Access Compliance Report Public Rights-of-Way (Curb Ramps)

Main Street: DORRANCE_DR		Cross Street: SIENNA_PKWY		Location:	W
ADA ID: RPRK211110130705	Ramp Type: Type 1 - Perpendicular	Initial Pass/Fail: Fail	Overall Compliance: No	Severity Score:	15

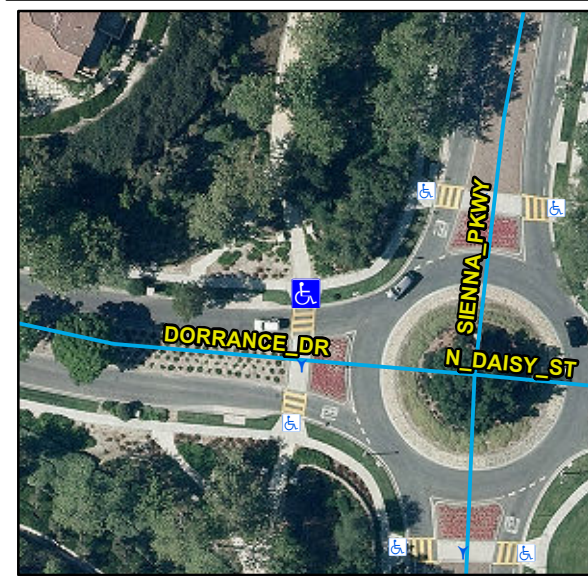
Compliance	Description	Data	Compliance	Description	Data
N/A	Ramp Length (in)	89	N/A	Flare Type LT	
Yes	Ramp Width (in)	48			N/A
No	Ramp Run Slope (%)	9.2	N/A	Flare Slope LT (%)	N/A
Yes	Ramp Cross Slope (%)	3.4	N/A	Flare Traversable LT	N/A
N/A	Landing Present	N/A	N/A	Flare Type RT	
N/A	Landing Length (in)	N/A			N/A
N/A	Landing Width (in)	N/A	N/A	Flare Slope RT (%)	N/A
N/A	Landing Run Slope (%)	N/A	N/A	Flare Traversable RT	N/A
N/A	Landing Cross Slope (%)	N/A	N/A	DWS Provided	N/A
N/A	Landing Movement Obstructed?	N/A	N/A	DWS Contrast	N/A
	Landing Movement Type	N/A	N/A	DWS Length (in)	N/A
N/A	Landing Shared	N/A	N/A	DWS Full Width	N/A
N/A	Clear Space	N/A	N/A	DWS Offset Left (in)	N/A
N/A	Clear Space To Crosswalk (in)	N/A	N/A	DWS Offset Right (in)	N/A
N/A	Marked Crosswalk 1	Yes	N/A	Marked Crosswalk 2	N/A
	Crossing 1 Direction	S		Crossing 2 Direction	N/A
	Marked Crosswalk 1 Width (in)	144		Marked Crosswalk 2 Width (in)	N/A

N/A	Ramp Inside Crosswalk 1	Yes	Yes	Ramp Inside Crosswalk 2	N/A
	Crossing 1 Slope (%)	1		Crossing 2 Slope (%)	N/A
	Crossing 1 Cross Slope (%)	3.8		Crossing 2 Cross Slope (%)	N/A
N/A	Gutter Ponding	N/A	No	Curb Slope	10.6
Yes	Gutter Lip Height (in)	0		Road Run Slope (%)	N/A
N/A	Gutter Run Slope (%)	N/A		Road Cross Slope (%)	N/A
N/A	Gutter Cross Slope (%)	N/A			
Yes	Overall Surface Condition: Acceptable		No	Perp Joint Present	No
	Cross Gutter Present?	No		Spandrel Present?	No
	Replace Cross Gutter?	N/A		Replace Spandrel?	N/A

Remove & Replace Entire Ramp.

R304.2.2, R204.3, STD 1115
